TECHNICAL EVALUATION REPORT

EVALUATION OF SPENT FUEL RACKS STRUCTURAL ANALYSIS

PHILADELPHIA ELECTRIC COMPANY

PEACH BOTTOM UNITS 2 AND 3

Figure 6. Reactor Building - Finite Element Model

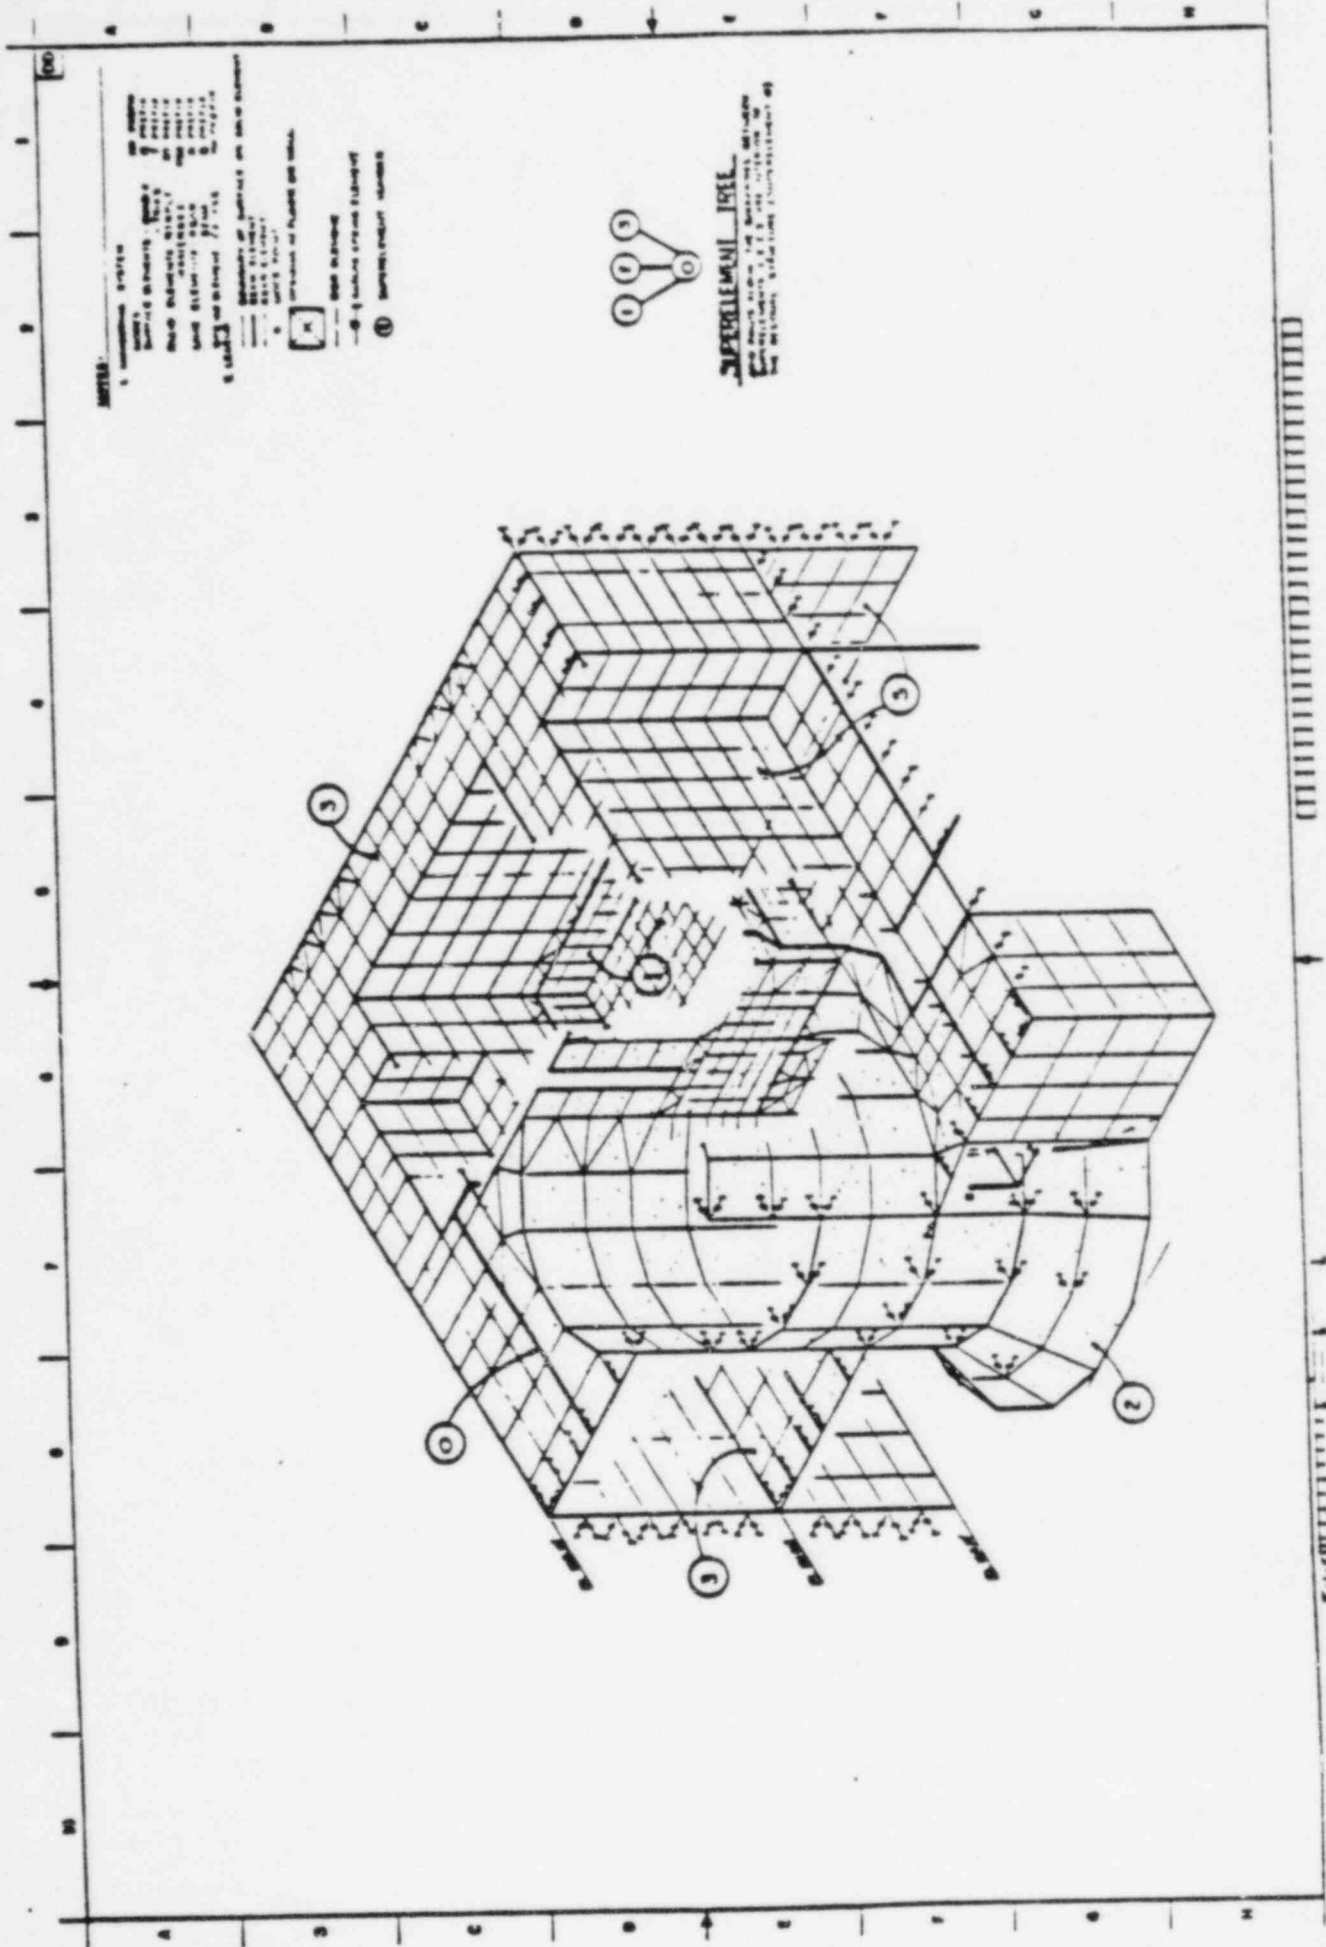
The Licensee employed the MSC/NASTRAN general purpose finite element program to investigate the spent fuel pool structure, using a three-dimensional finite model that included the entire spent fuel pool structure as well as adjacent key structural members. The model is shown in Figure 6. The Licensee provided the following additional features of the model [1]:

While this was a linear mathematical model, the Licensee applied the external loads in increments to perform a piecewise linear solution to the nonlinear problem of cracking in the concrete under tensile stresses. Checking of the computed stresses against the concrete cracking criterion and

Evaluation of the spent fuel pool analysis indicated that the analysis is satisfactory and that the spent fuel pool structure is adequate for the increased density of fuel storage.
